# Access Compliance Report

## Public Rights-of-Way

Intersection ID: 1002389	Main Street: DAVID_TAYLOR_DR	Cross Street: N/A	Location: W
ADA ID: 17BF4FC857E1	Ramp Type: Perp	Initial Pass/Fail: Fail	Overall Compliance: No
			Severity Score: 33.75

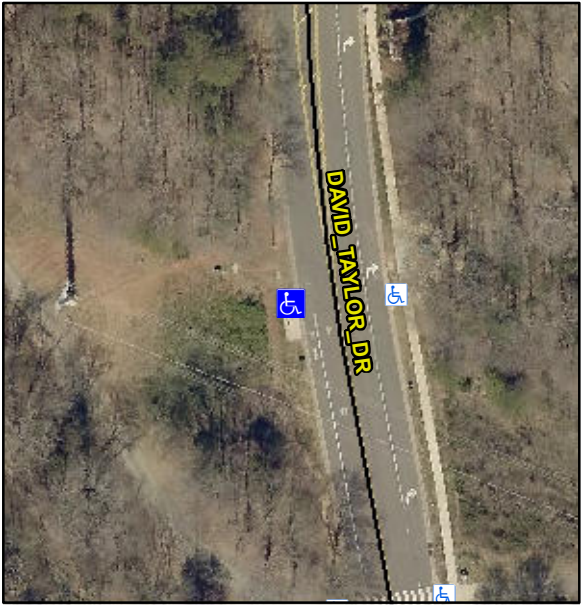
Codes/Mitigation Info/Possible Solution			Field Measurements/Component Compliance		
	Possible Solutions:		<b>Compliance</b>	<b>Description</b>	<b>Data</b>
	Remove & Replace Entire Ramp.		N/A	Ramp Length (in)	96.0
			No	Ramp Width (in)	47.0
			N/A	Flare Type LT	N/A
			N/A	Flare Slope LT (%)	N/A
			N/A	Flare Traversable LT?	N/A
			N/A	Landing Length (in)	N/A
			N/A	Landing Width (in)	N/A
			N/A	Landing Slope (%)	N/A
			N/A	Landing X Slope (%)	N/A
<p>Surveyor Notes:</p> <p>N/A</p> <p>PROW/ADA:</p> <p>R304.5.1, R304.2.2</p>			N/A	Flare Type RT	N/A
			N/A	Flare Slope RT (%)	N/A
			N/A	Flare Traversable RT?	N/A
			N/A	DWS Provided?	N/A
			N/A	DWS Contrast?	N/A
			N/A	DWS Length (in)	N/A
			N/A	DWS Full Width?	N/A
			N/A	DWS Offset (in)	N/A
			N/A	Gutter Ponding?	N/A
			N/A	Gutter Lip Ht (in)	N/A
<p>Total Cost:</p> <p>\$ 1850.00</p>			No	Painted X Walk1?	N/A
				X Walk 1 Direction	To E
			N/A	X Walk 1 Width (in)	N/A
				X Walk 1 Slope (%)	2.9

X Walk 1 X Slope (%)	1.3
			N/A	Ramp inside XWalk1?	N/A
				Road Slope (%)	N/A
				Road X Slope (%)	N/A
			N/A	Any Obstructions?	N/A
				Obstruction Type	
			N/A	Clear Space?	N/A
				Clear Space to XWalk (in)	N/A
			N/A	Storm Grate/Utility Hazard?	N/A
				Storm Grate/Utility Type	
			N/A		N/A
			Yes	Surface Condition? (G/P)	Good
